City of Phoenix

Staff Report Z-77-08-8 and Z-SP-20-08-8

Proposed Use Automobile sales & service

Location Approximately 204 feet north of the northeast corner of South 16th Street and East Wood Street

CITY OF PHOENIX
AUG 19 2008
Planning Department

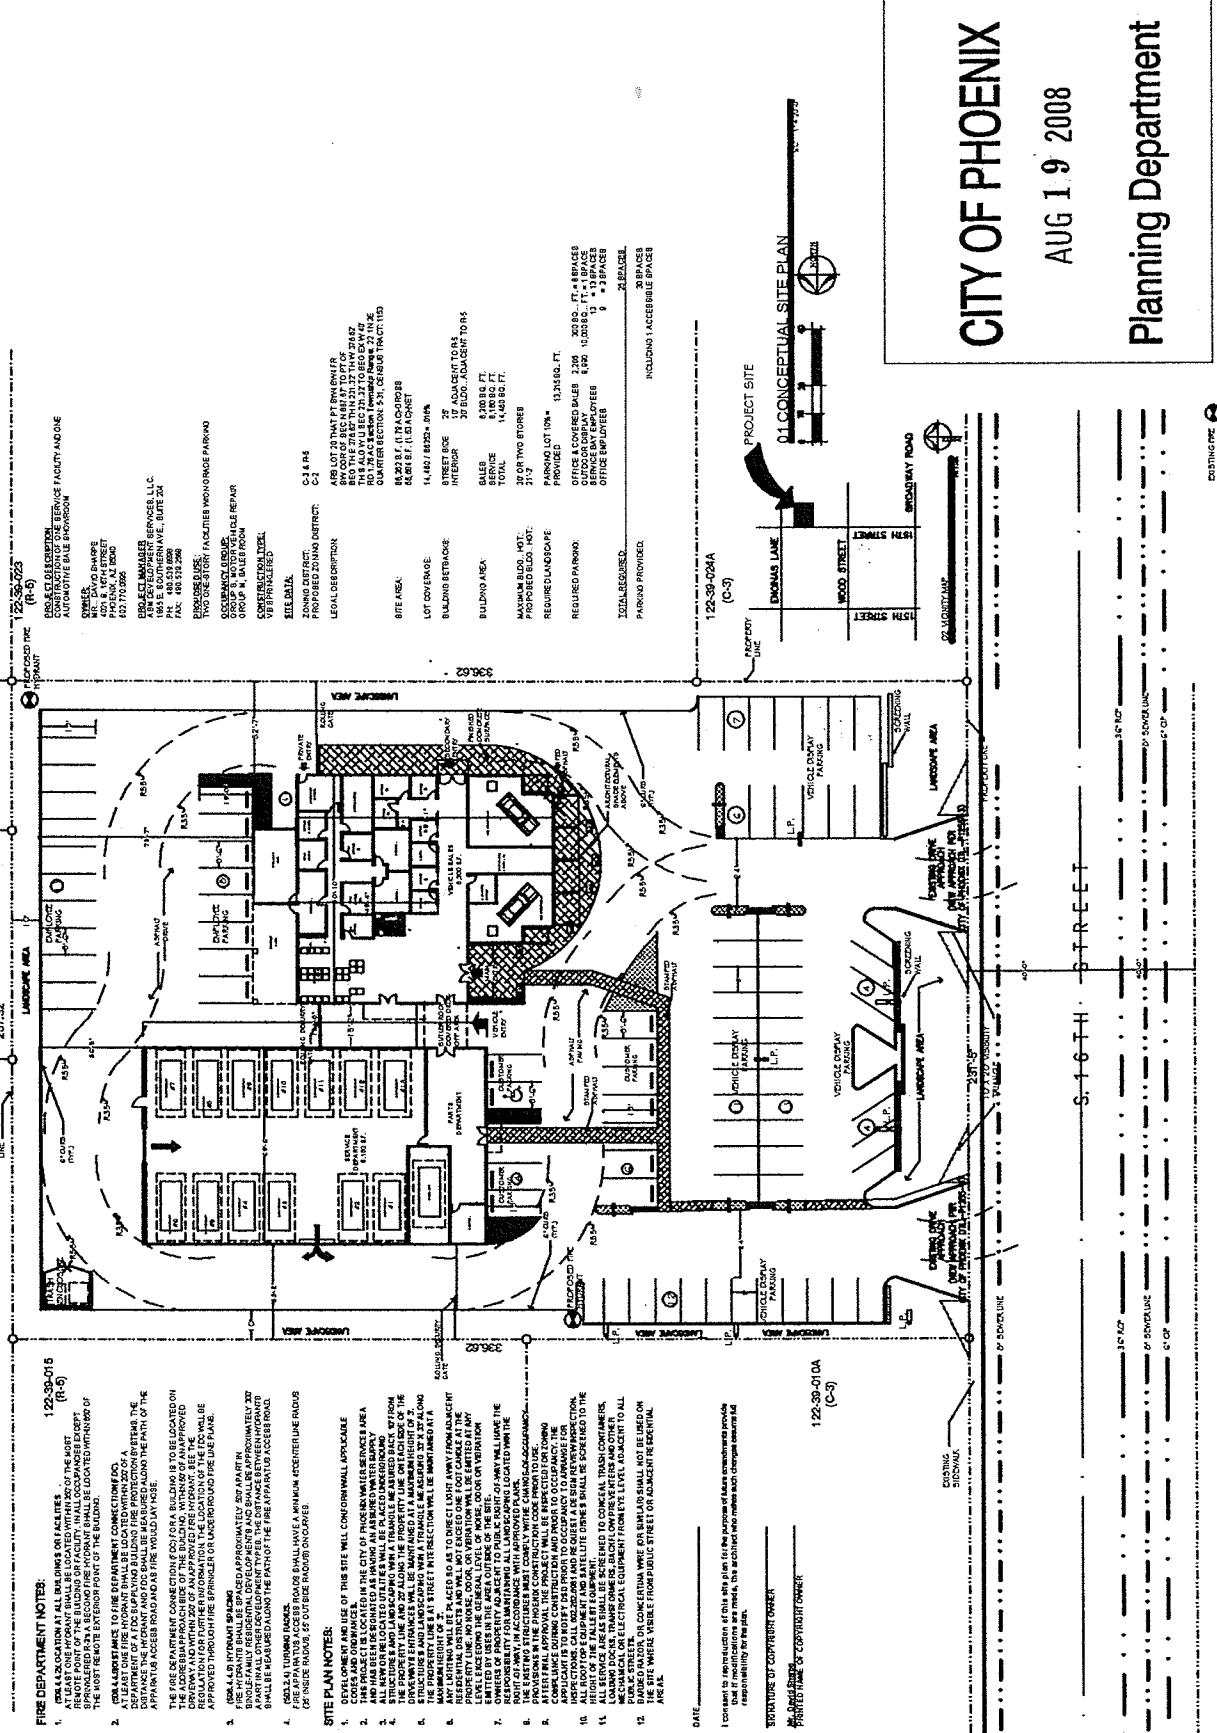
The site plan shows the front portion of the property along 16th Street, as primarily the vehicle display area with existing C-3 zoning that allows the car sales use by right. The applicant has agreed to add a minimum of six foot planter areas with shade trees in the existing C-3 zoned display area. There are also two existing driveway approaches to the site from 16th Street. On the south end of the proposed C-2 SP RSIOD portion, there is an area for vehicle sales which is in an enclosed building and contains several offices and showrooms. On the north end there is an enclosed service area which has an entrance on the north side of the building. The customer parking area is located to the west behind the vehicle display area and the employee parking area is at the east end of the site. The site plan does not show a wall surrounding the site. A wall will be required and the height of the wall is 8 feet since the used car and service area is located next to the R-4 district.

1. That the development shall be in general conformance to the site plan and landscape plan date stamped August 19, 2008 as approved or modified by the Development Services Department.
2. That the development shall be in general conformance to the elevation date stamped August 19, 2008, as approved or modified by the Development Services Department and include the following:
 - a. That the buildings shall include architectural embellishments consisting of windows with awnings, tile or rock wainscoting, and polished metal clad.
3. That no outside amplification or speakers shall be installed as part of this development.

01 FRONT ELEVATION

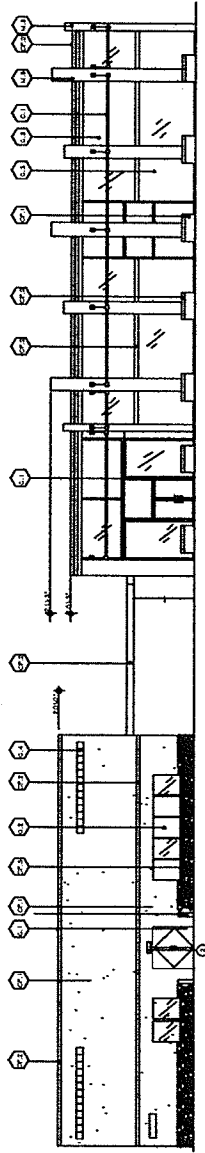
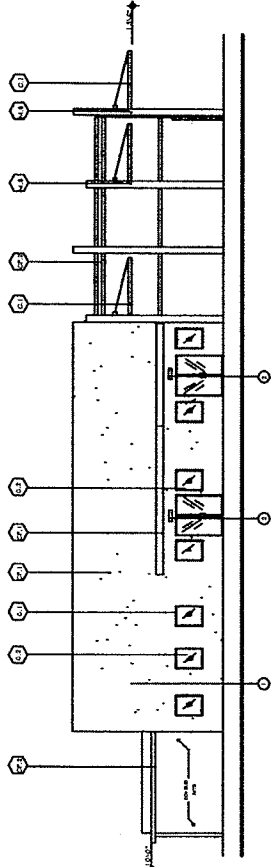
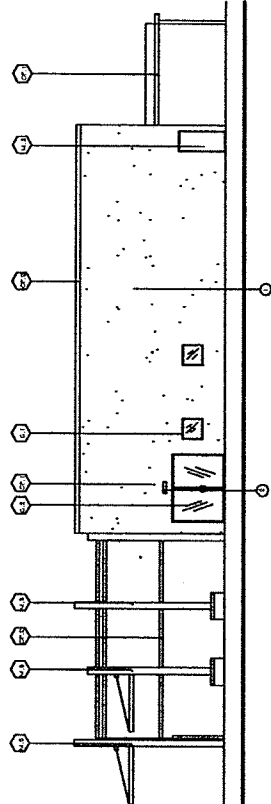
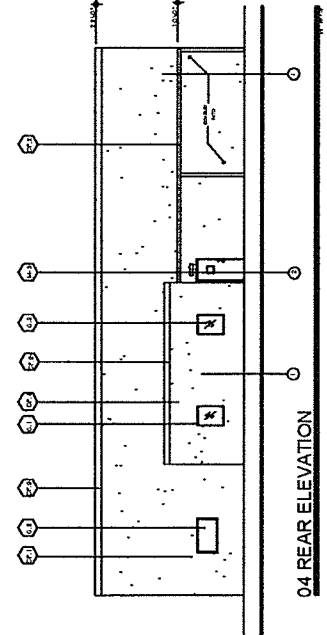
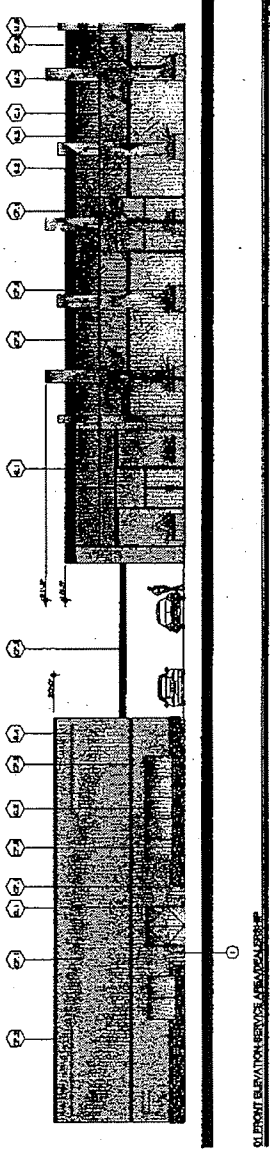
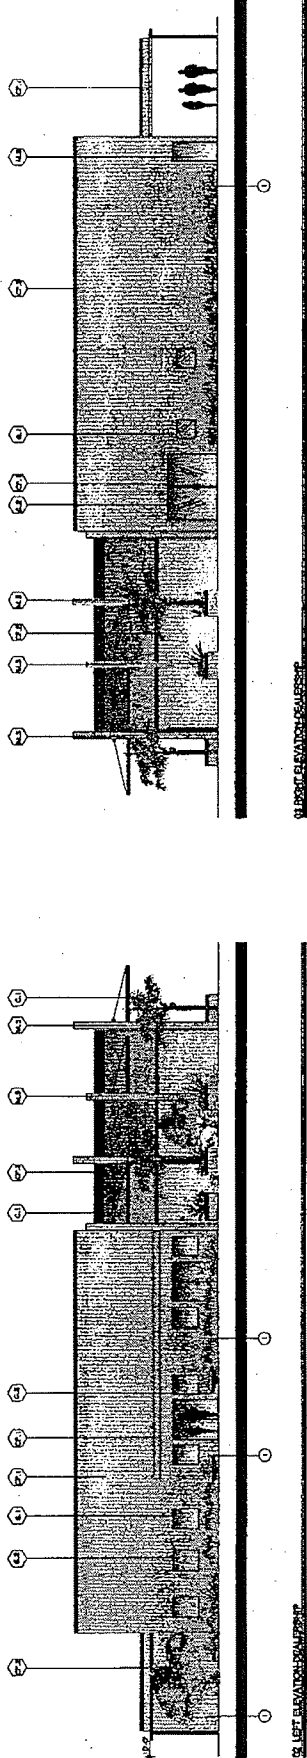
The elevations show a one-story all glass entrance to the service area dealership building. The entrance amenities consist of polish metal clad, trees and plants. The remainder of the building has very little architectural embellishments which is not in keeping with Section 507 of the Zoning Ordinance that requires design features on all sides of a building. Suggested improvements should consist of marble or shale wainscoting surrounding the building, sconce lighting, and windows with awnings.
